City of Aurora Building Division
Project: *Tenant Improvement*
Address: *1444 S POTOMAC ST Unit 100*
Occupancy Group: *IBC B*
Construction Type: *IBC IIB-SPK*
RSN: *1722084*
Permit: *23-2344729-LT*

City of Aurora Building Division
Reviewed for Code Compliance
Approved as Noted: Matt A.
Date: Jul 03, 2023
2021 INTERNATIONAL CODES & 2020 NEC

Sanders and Soult Family Dentistry
Tenant Remodel
1444 S. Potomac Suite 100
Aurora, CO

PROJECT NUMBER: SS101
DRAWN BY: HR
CHECKED BY: HR
SHEET TITLE: EGRESS PLAN
SHEET NUMBER: A001

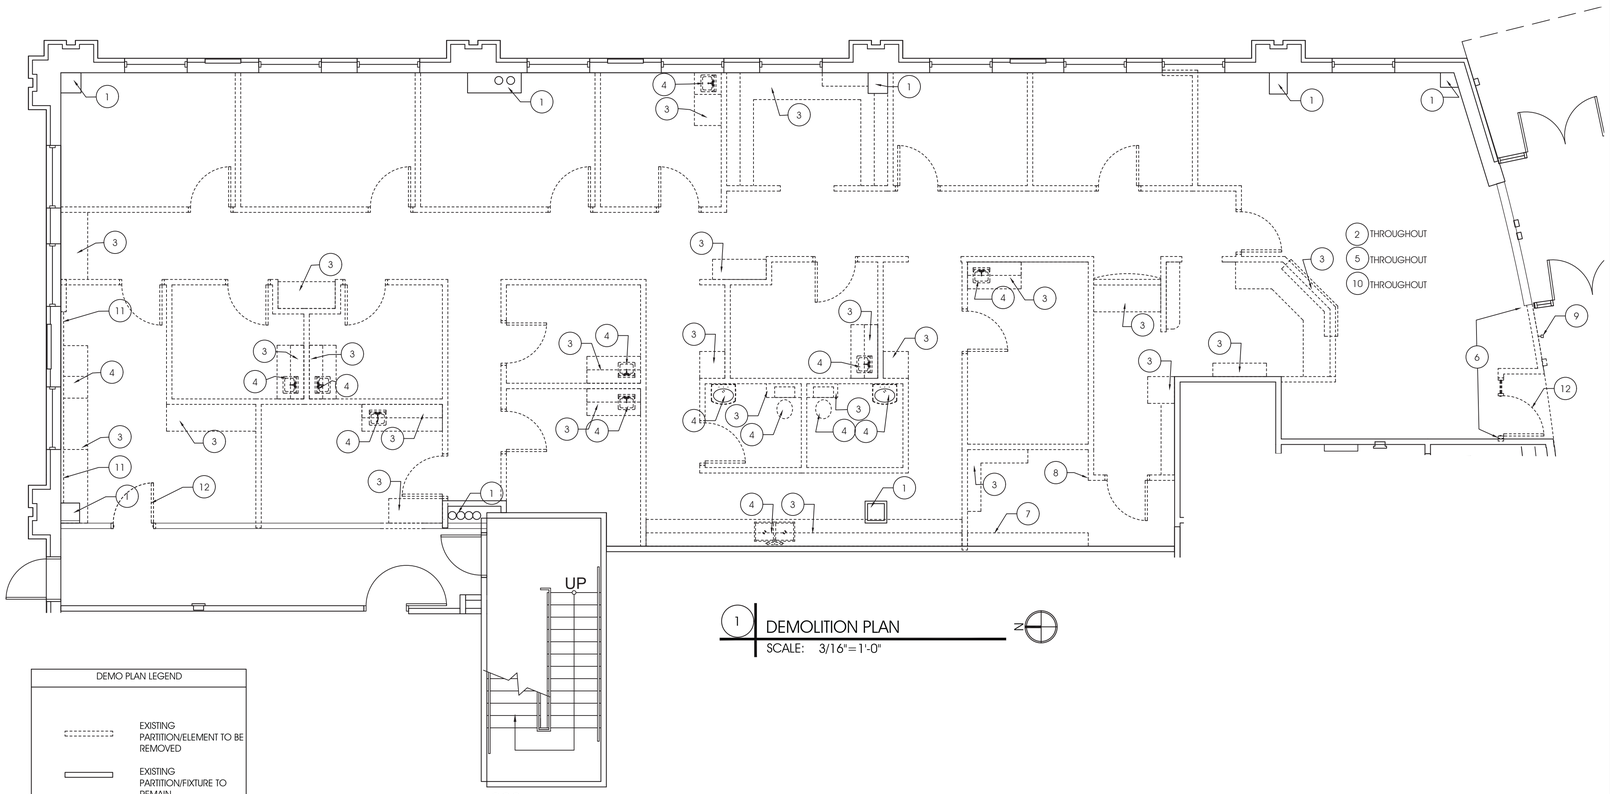
Provide a sign stating "**EXIT**" in raised, visual characters and braille and complying with **ICC A117.1** adjacent to each door in an area of refuge, an exterior area for assisted rescue, an exit stairway or ramp, an exit passageway, a horizontal exit and the exit discharge. **2021 IBC 1013.4**

PROJECT NUMBER: SS101
DRAWN BY: HR
CHECKED BY: HR
SHEET TITLE: DOORS AND GLAZING
SHEET NUMBER: A201

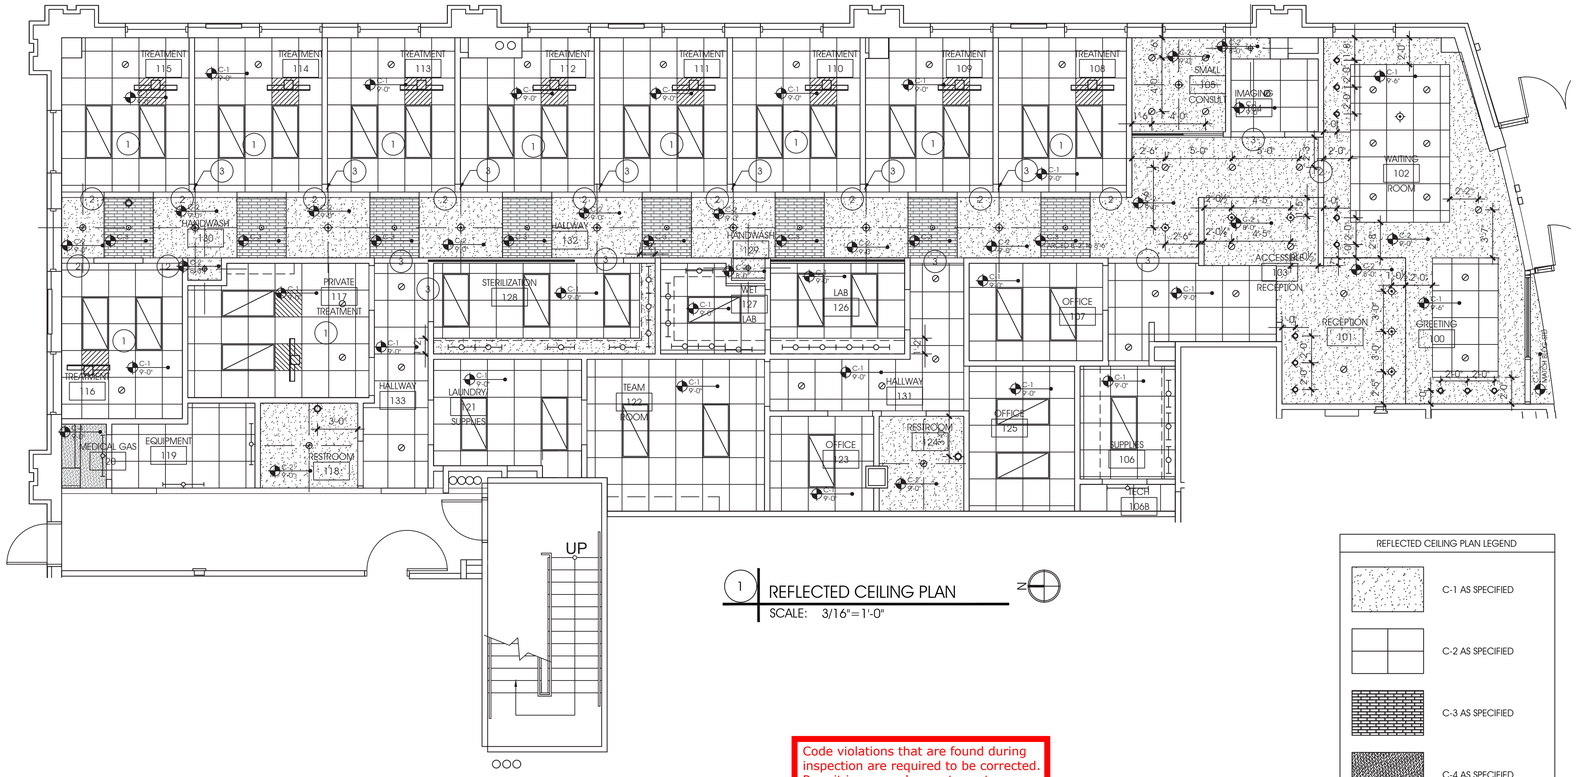
Provide lever or other approved hardware on all new and relocated doors. **2017 ICC/ANSI 117.7 309.4**

PROJECT NUMBER: SS101
DRAWN BY: HR
CHECKED BY: HR
SHEET TITLE: MILLWORK/ DETAILS
SHEET NUMBER: A900

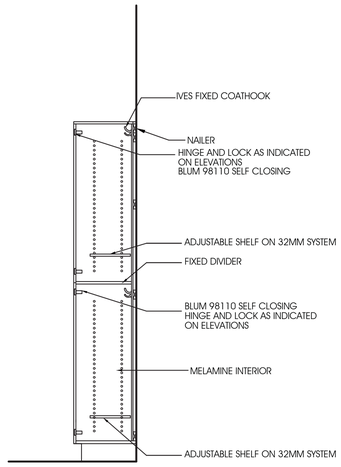
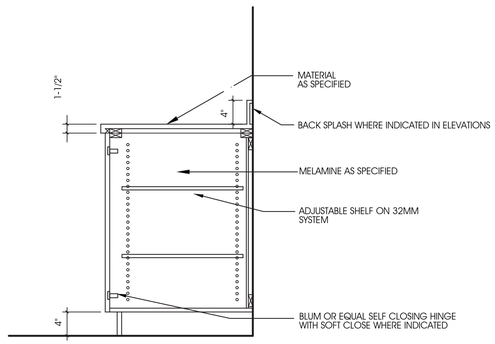
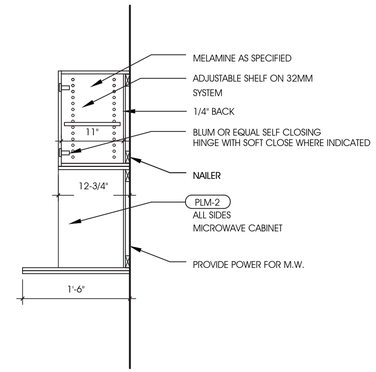
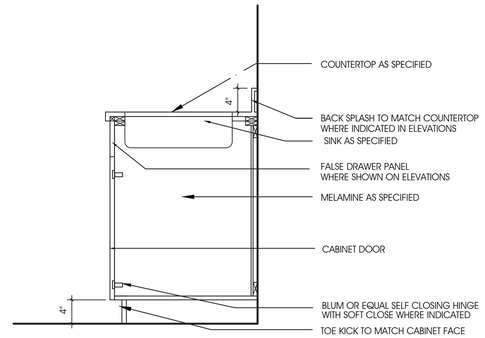
SALES AND SERVICE COUNTERS AND WINDOWS SHALL COMPLY WITH **A117.1-2017 SECTION 904.3** FOR ACCESSIBILITY REQUIREMENTS

SHEET NUMBER: A901

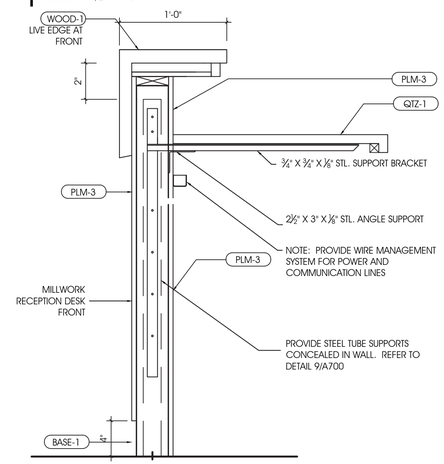
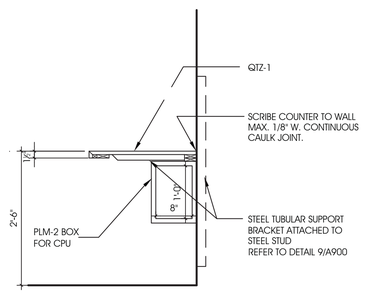
SALES AND SERVICE COUNTERS AND WINDOWS SHALL COMPLY WITH **A117.1-2017 SECTION 904.3** FOR ACCESSIBILITY REQUIREMENTS

SHEET NUMBER: **P-701**

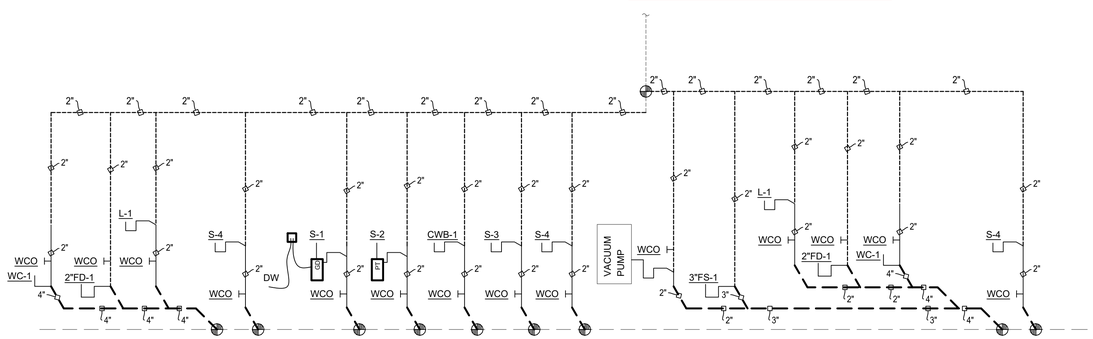
The dry vent must rise 6" vertically above the flood level rim of the highest trapped fixture being vented. 2021 IPC 905.4

Provide drains no smaller than allowed by 2021 IPC 709.1 and 710.1(1)

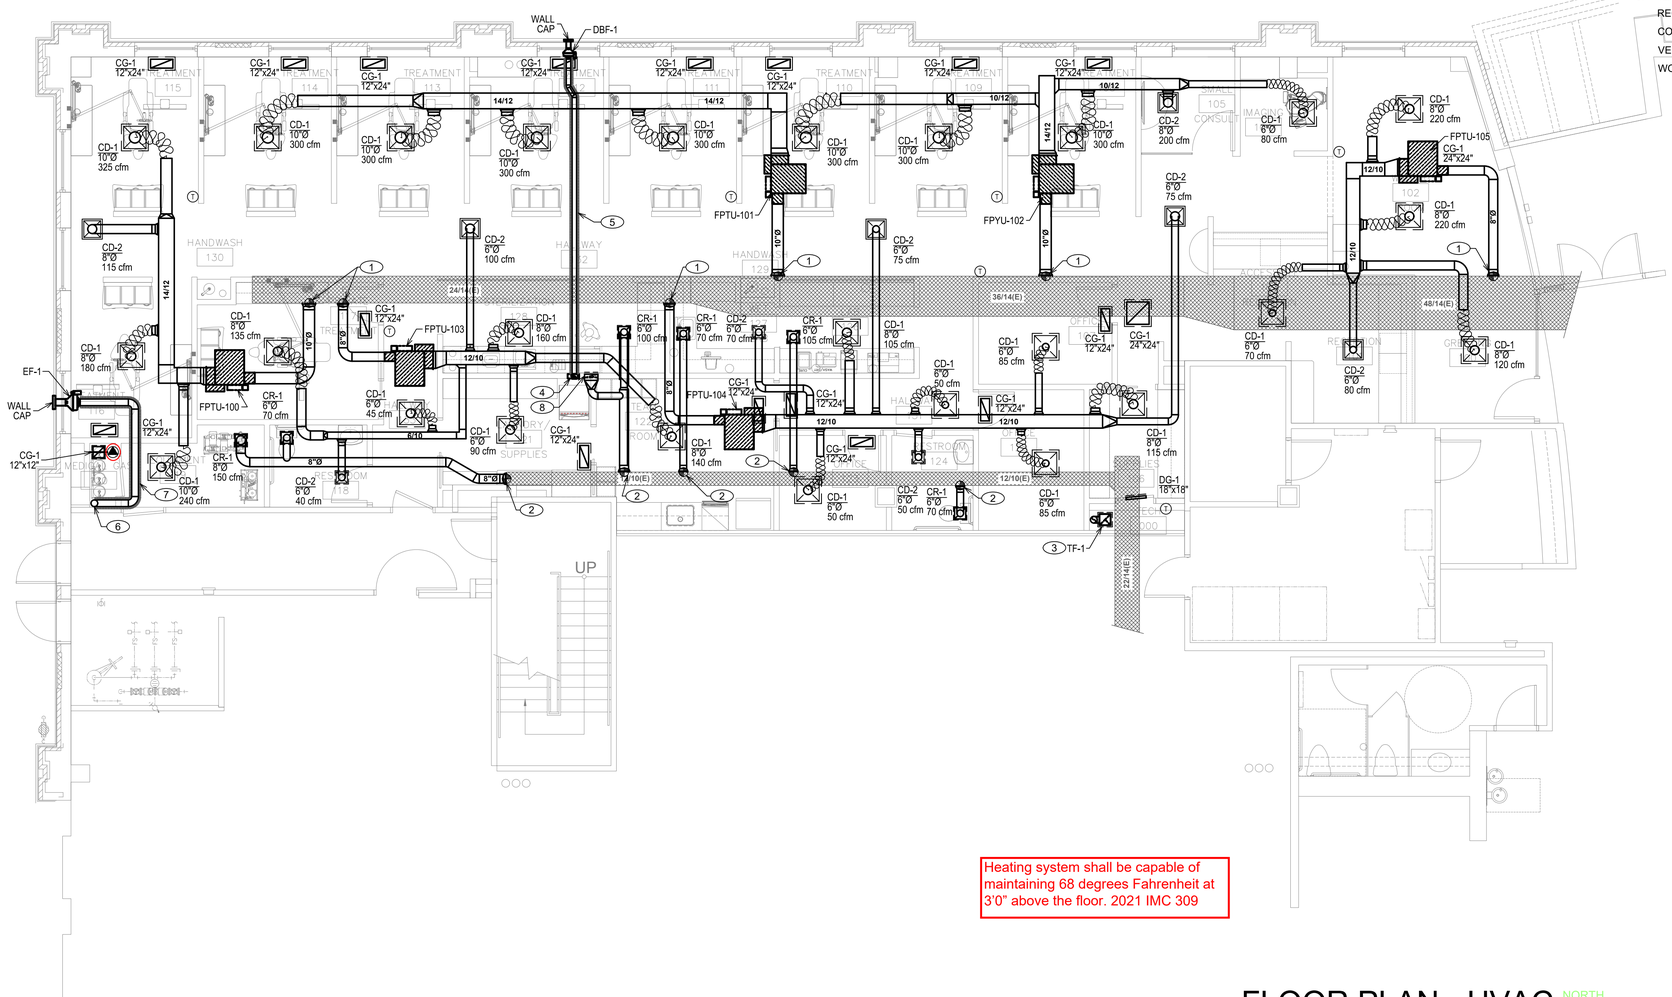
Plastic fire sprinkler piping exposed within a plenum shall be used only in wet pipe systems and shall have a maximum: peak optical density of 0.50; average optical density of 0.15; flame spread of 5 feet in accordance with UL 1887. Piping shall be listed and labeled. 2021 IMC 602.2.1.2

Provide proof of a flame spread less than 26 and a smoke development less than 50 for any material used in a plenum. 2021 IMC 602.2.1

Heating system shall be capable of maintaining 68 degrees Fahrenheit at 3'0" above the floor. 2021 IMC 309
